Carisbrook Levee Review Report

Review of Floodplain Management since 2013

Report Number: P-FY20242892-PWO-DAM-RP-001

August 2024

Figure 4-20 Design Flood Depths

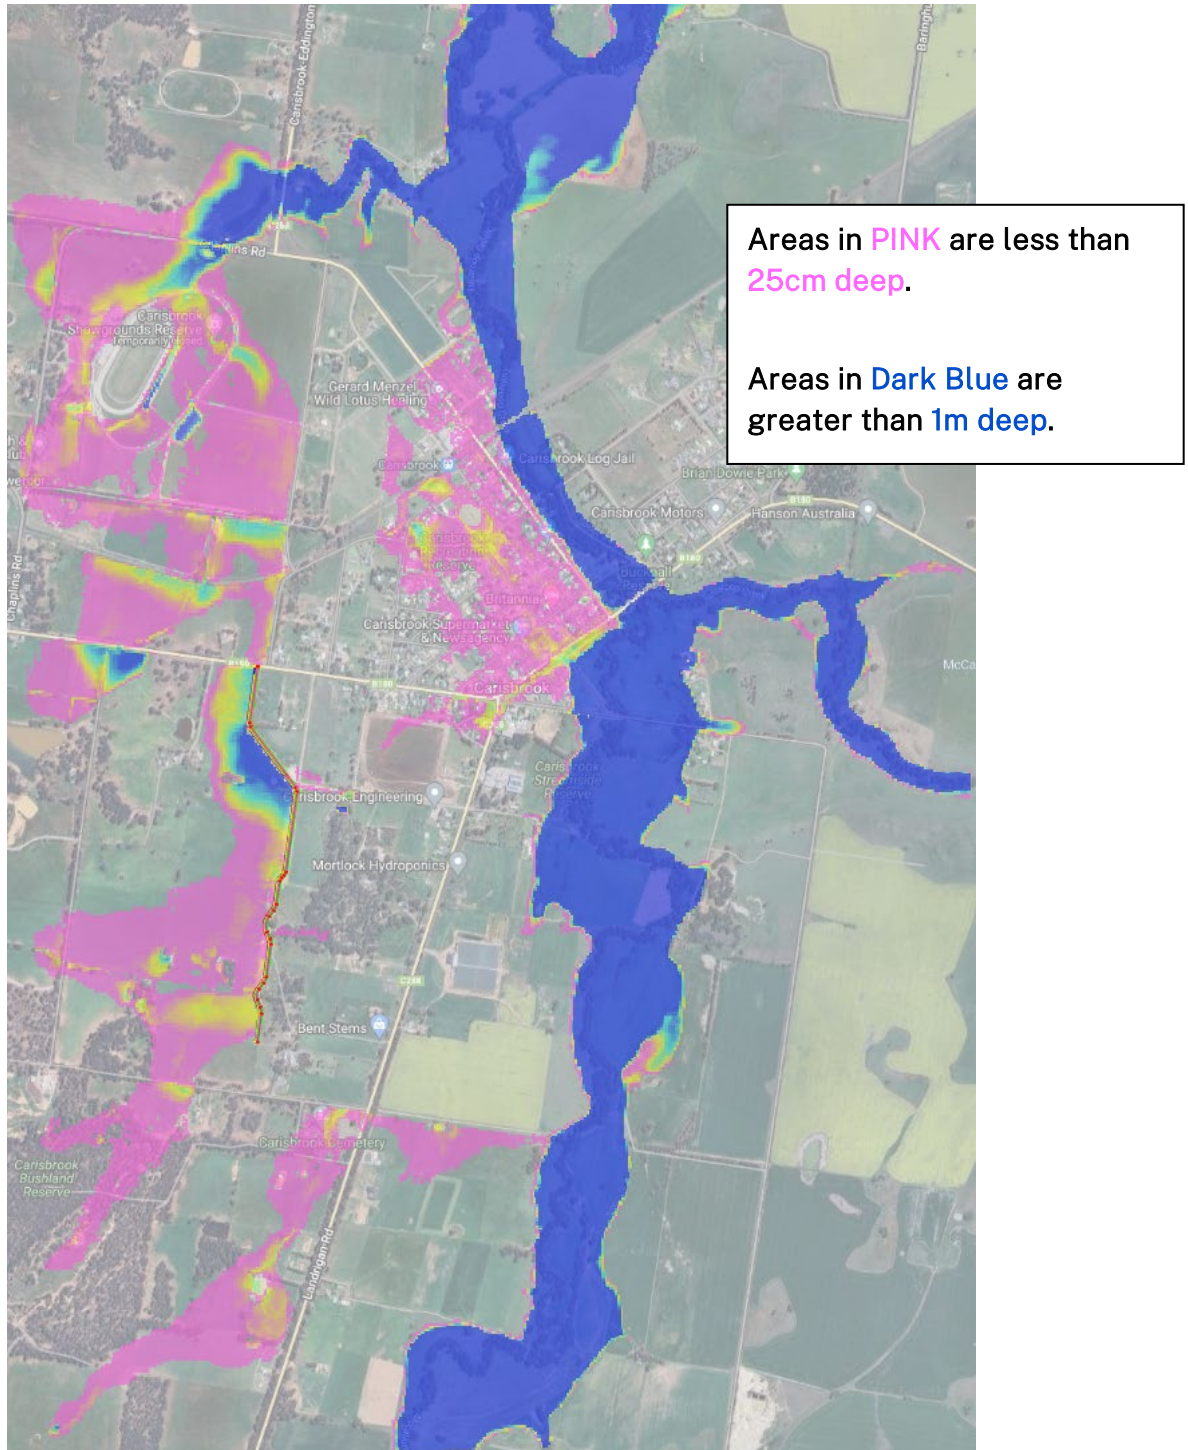
It should also be noted that a lot of the flood water is LESS THAN 25cm deep (as per the pink areas below). These small depths are very susceptible to variation both in the inaccuracy of the LIDAR survey, the modelling and any later activities that may (inadvertently) be done.

- What if a farmer decides to plough up a paddock (to say plant feed oats) and changes the level of the paddock?
- What if someone puts in, what they consider to be, a small height contour bank or even a block bank to stop what they consider to be “nuisance” water?

This would change how water behaves on the floodplain.

For the Critical Design Storm MIKE FLOOD Model run, run an additional scenario with up to (say) ten culverts under the Pyrenees Highway (noting that there is a house to the northwest of the culvert outlet). Include any additional culverts needed underneath the railway line also.

Figure 4-22 Flooding through / under railway line west of Pleasant and High Street

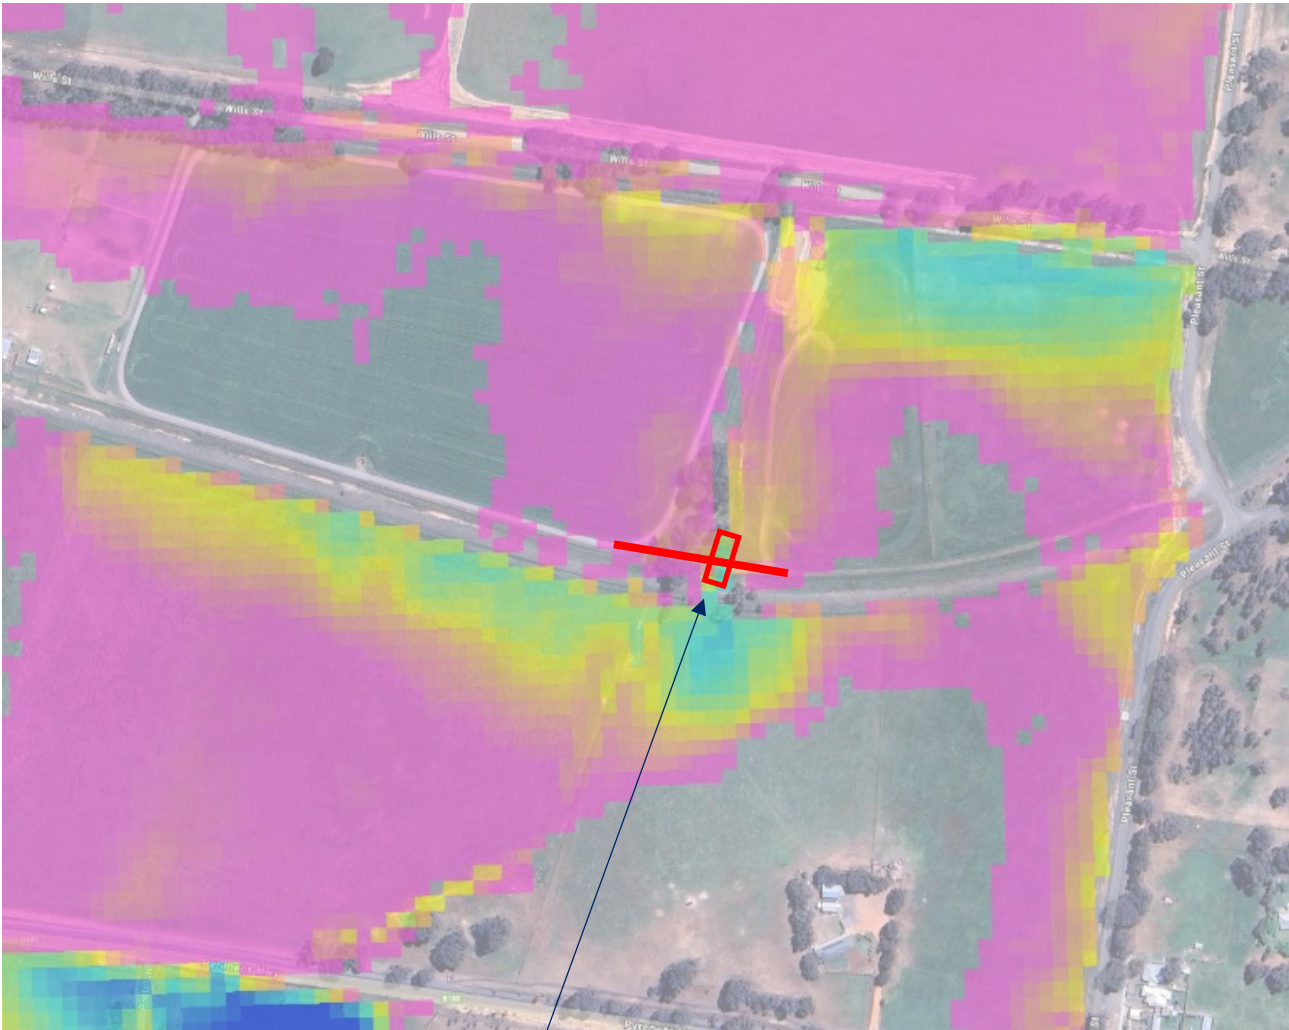
6. The existing culverts under the railway line further west are a VITAL component of the Flood Protection System. That is, they allow a major portion of the floodwater to pass northwards without going through the cutting near Pleasant Street / High Street. It is vitally important that there is nothing to impede those flows. It is for this reason that (minimum) yearly (if not seasonal) inspections be undertaken, and repair work be undertaken IMMEDIATELY when defects (of any severity) are found. That is, there must be a HIGH level of inspection and diligence (and budget) to ensure the Levee Bank is “Operationally Ready” at all times.

There is already an embankment (with a 700mm diameter pipe through it) blocking the northern side of the 16m wide railway culverts. The modelled depth of water where the block bank and pipe are located is only 750mm. That is, the flow of water through the railway culverts appears to be entirely cut off.

Figure 4-26 Location of Northern end of Western Levee (Engeny 2024)

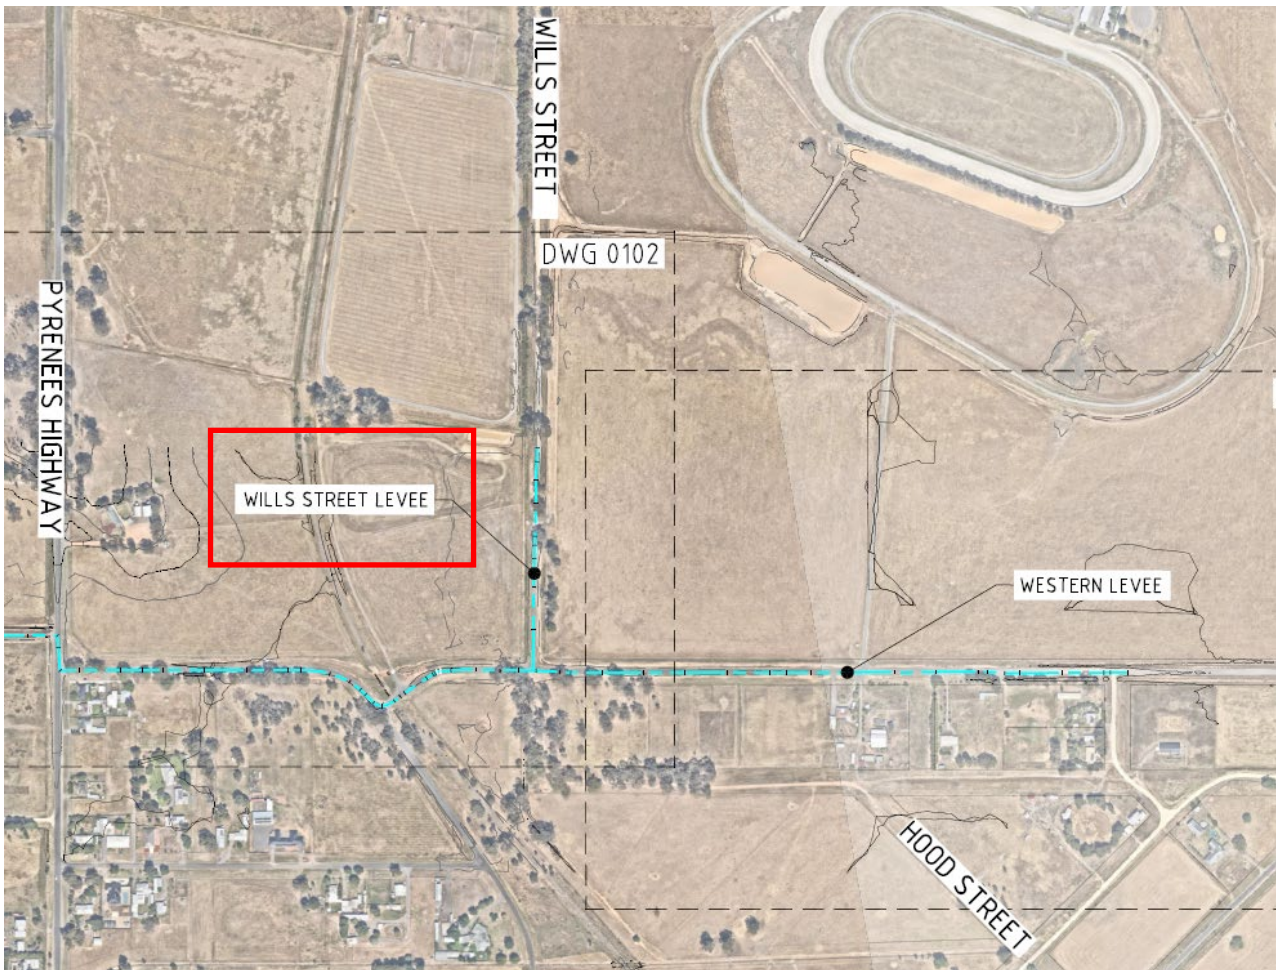
The 2019 Flood Study makes no mention of there being a Levee Bank running down Wills Street, nor was it modelled as such. However, the (draft) Flood Levee Management Plan (Engeny May 2024) has labelled 270m of Wills Street as a levee and even produced a long section stating such. Apart from a small ramp off pleasant Street, there is no levee bank on Wills Street.

There is NO levee bank on Wills Street. All references to there being one should be deleted from the (draft) Flood Levee Management Plan.

Figure 4-27 Longsection of the supposed Wills Street Levee (Engeny 2024)

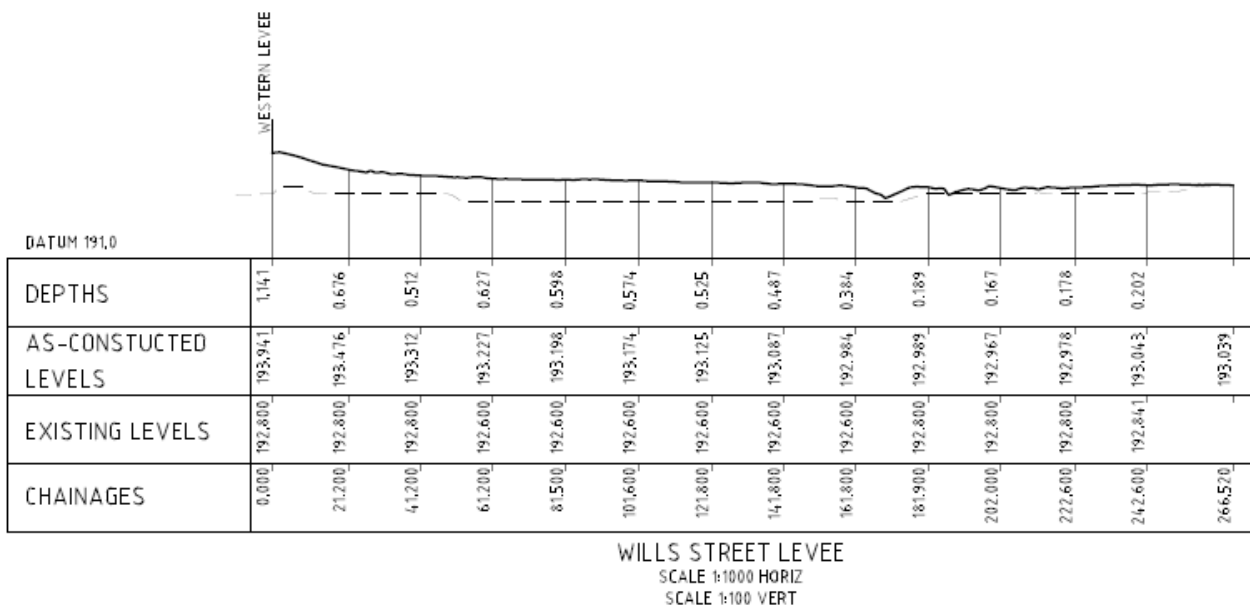
“Wills Street was planned to be raised gradually, for 50m, before reaching Pleasant Street to match its new top level” and makes mention of the channel running down Wills Street for 270m to a low point. That corresponds to a description of a ramp only.

Figure 4-28 End of Levee Pleasant Street / Racecourse

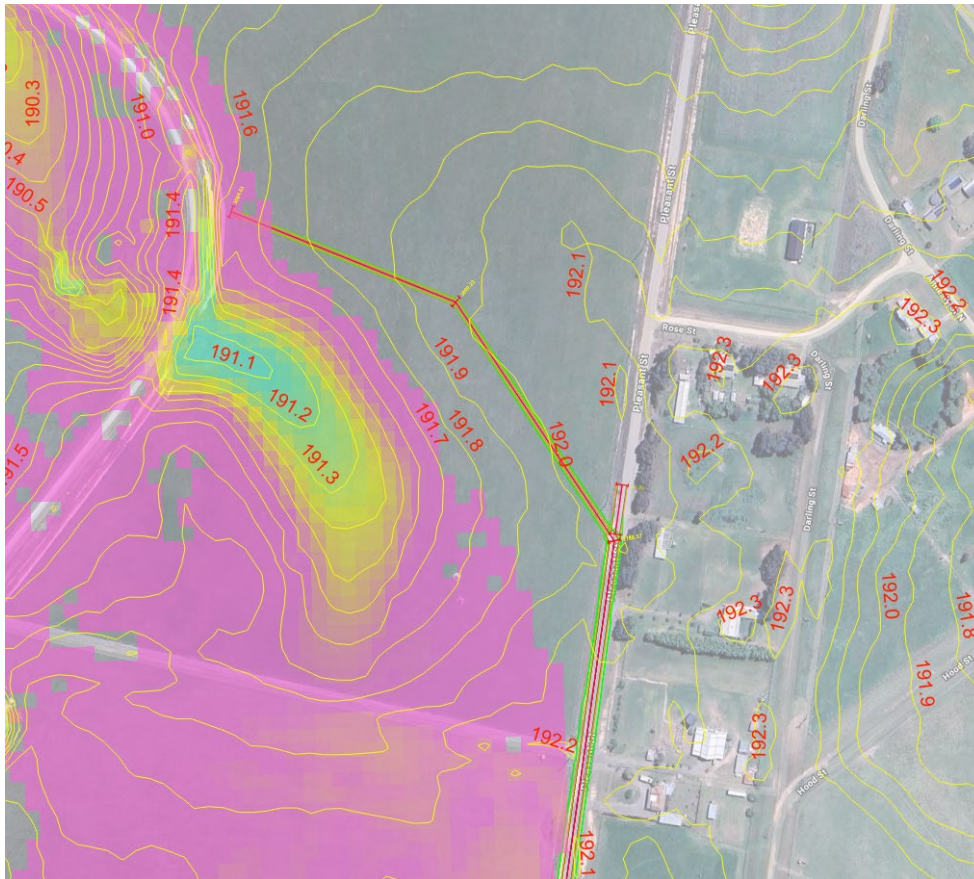
On all the design plans as well as the (draft) Flood Levee Management Plan and the Flood Model all show a levee bank continuing from Pleasant Street across the Racecourse property and terminating. Council advised that they did not construct this section as the ground levels were found to be high enough during construction.

If the actual ground levels, as surveyed by Entura / Council (presumably using State Survey benchmarks not LIDAR), show that the ground levels are higher than the LIDAR, this indicates that the LIDAR may not be correct in their entirety. That is, the design flood levels from the model would be higher than those used to construct the levee bank itself using State Survey benchmarks. Entura did not compare their topographic survey (done in 2014) to the 2011 LIDAR.

Extend the levee bank across the racecourse as designed (unless ground levels surveyed using RTK method) shows otherwise.

Figure 4-34 No Vegetation Management of Creek – Carisbrook Floods

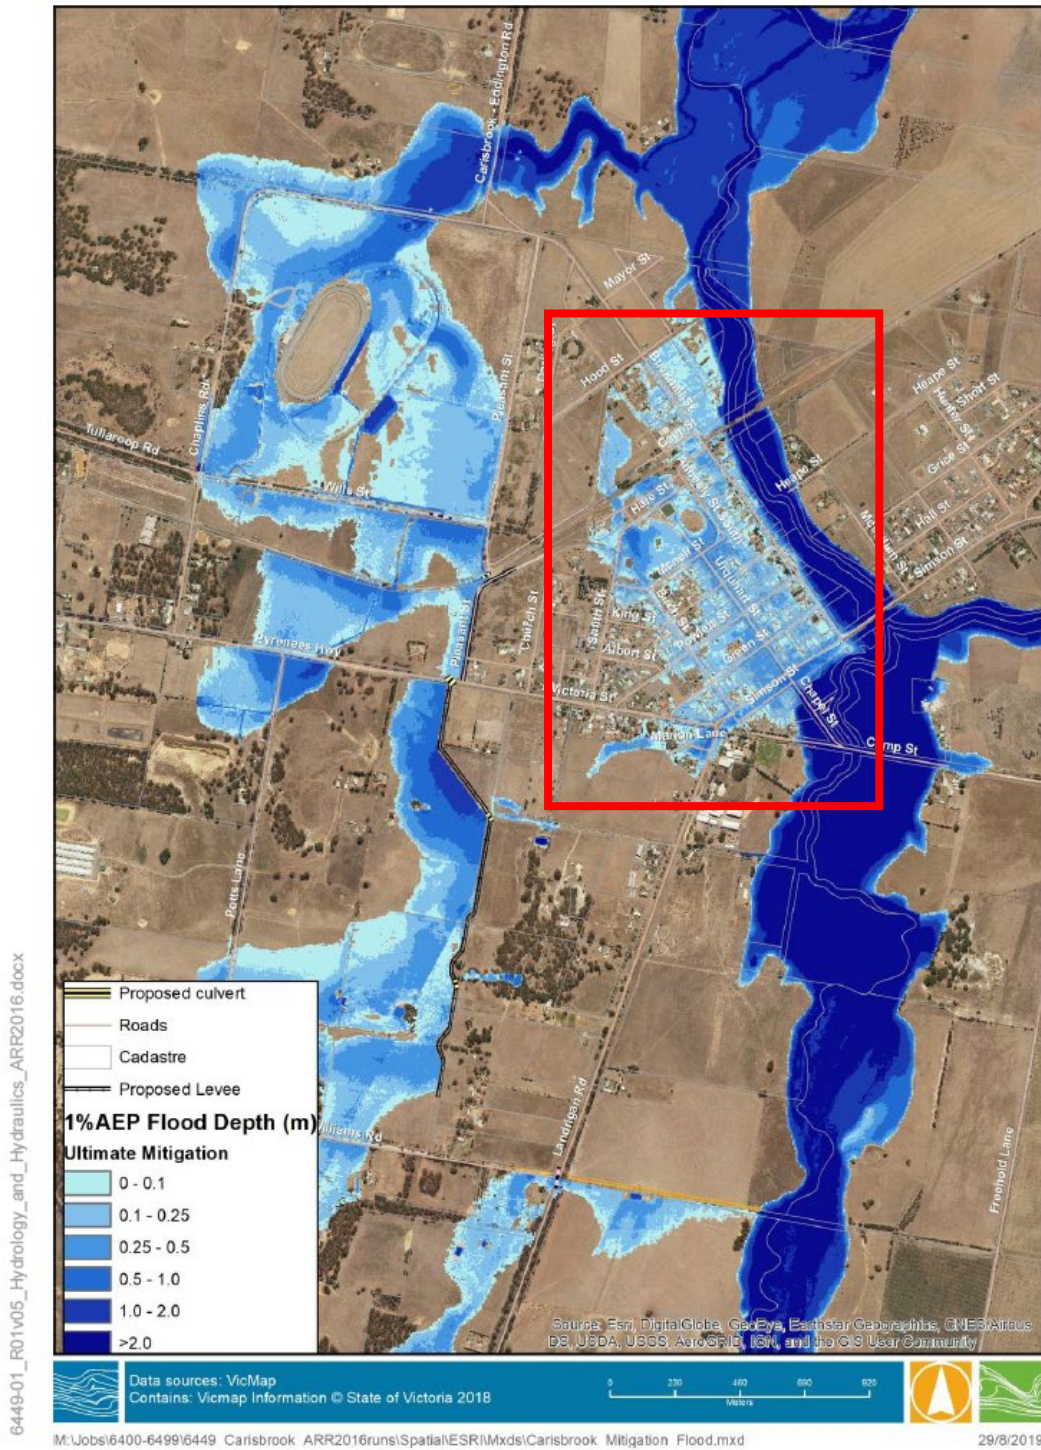
It is to be noted that the 2019 Flood Study did NOT model the Vegetation Management works as part of the Ultimate Flood Mitigation” option. This is why the modelling results show that Carisbrook is flooded albeit to depths (mostly) between 10cm and 25cm.

It was stated “The design hydraulic modelling adopted previous study design roughness in the creek (no post debris and veg removal work)”.

Figure 4-37 Stormwater Pipe Network

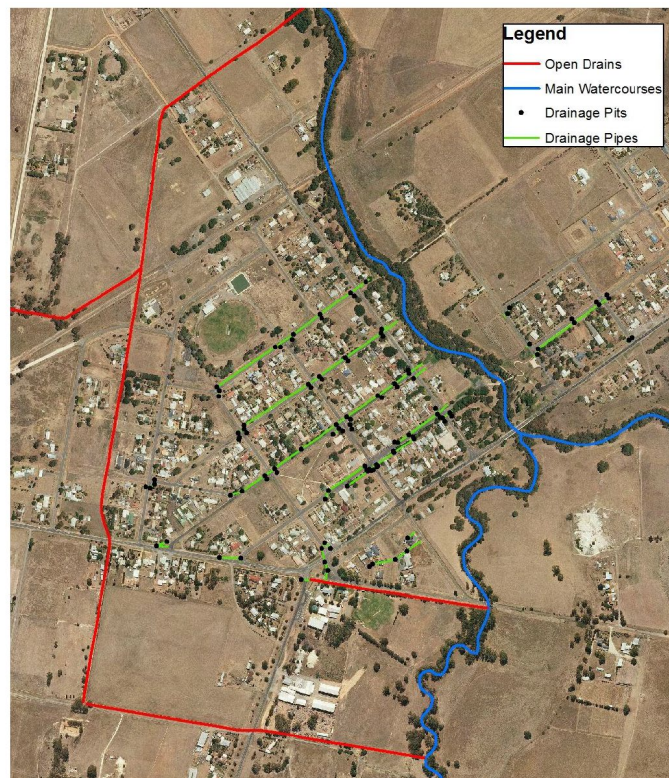
It is expected that there may be more pipes and culverts under Bucknall Street and Pyrenees Highway than are shown in Council’s Asset Register.

The installation / closure at pre-set rainfall amounts and/or flood levels are to be included in the Levee Management Plan.

Figure 4-40 Modelled depth of flood water around Cemetery (mostly less than 25cm)

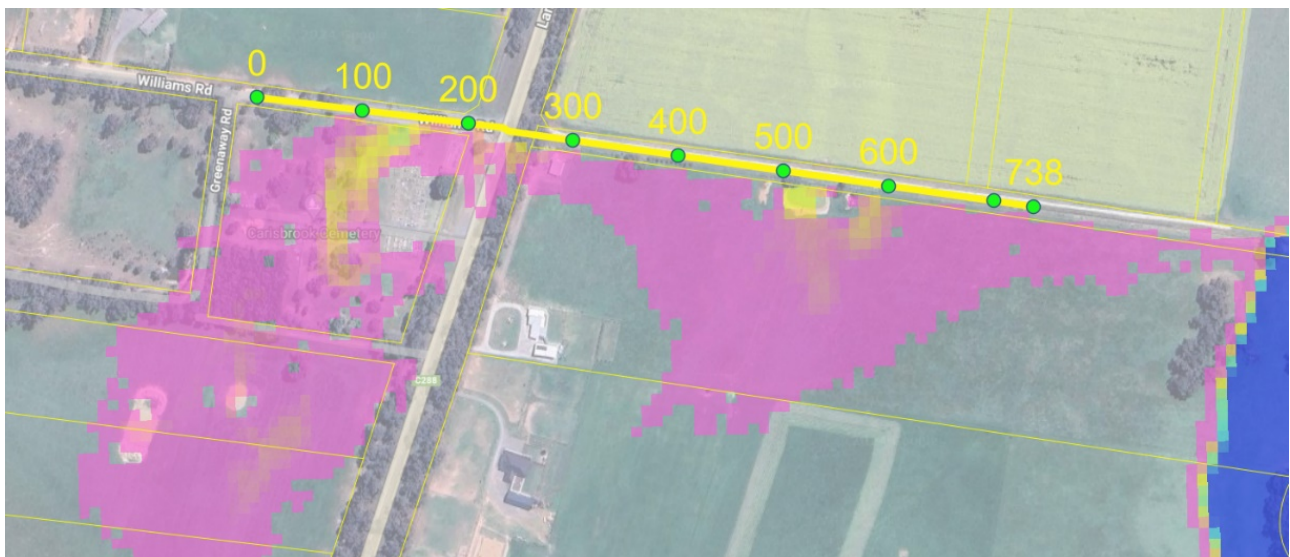
Given that a Levee Bank (on Williams Road) is a FLOOD MODIFICATION measure it is not surprising that water “now goes where it didn’t before” as has been reported doing so. After all, the whole purpose of a Levee Bank is to redirect water flow.

From a visual inspection of the culvert under Landrigan Road and the start of the Bluestone Drain heading east, it appears that invert level of the culvert is much lower than the invert level of the drain. If this is found to be the case, this would mean that the culvert is “effectively 80% blocked” and would cause water to back up into and sit in the Cemetery for a longer period of time and to a greater extent.

Figure 5-1 Modelling results – 2013 Flood Study

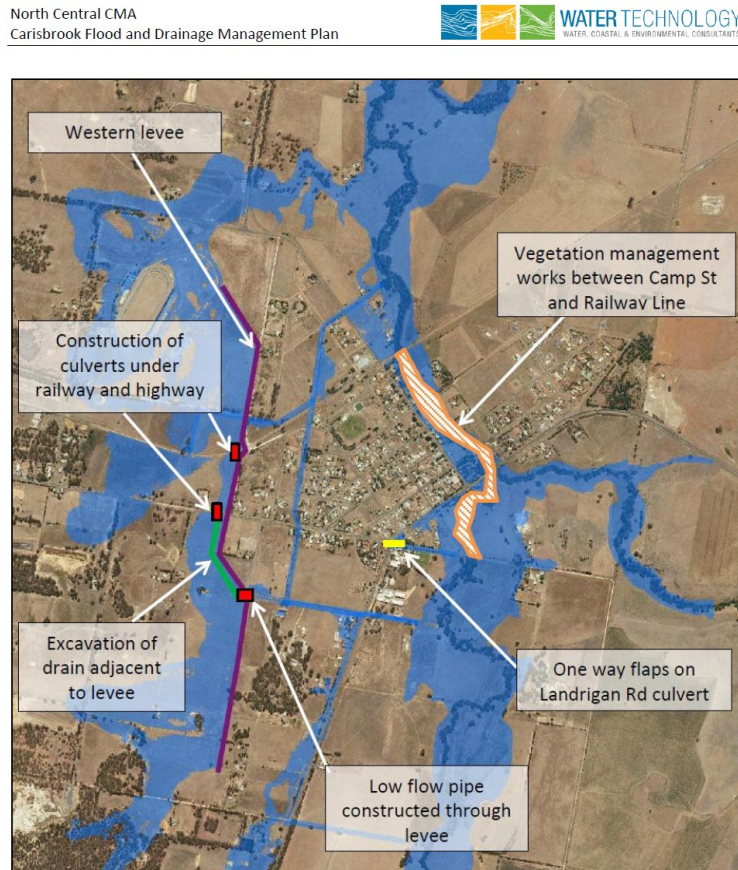
serve two purposes and often times a “road embankment” becomes a “levee bank” by nothing more than “it is there stopping water”. That is, it functions as a levee bank.

All culverts under this “levee” should either have Flap Valves or (preferably) Gate Valves fitted or Plugs to be placed in them during a flood event. The location and operation (where, when and who operates) are to be specifically included in the Levee Management Plan.
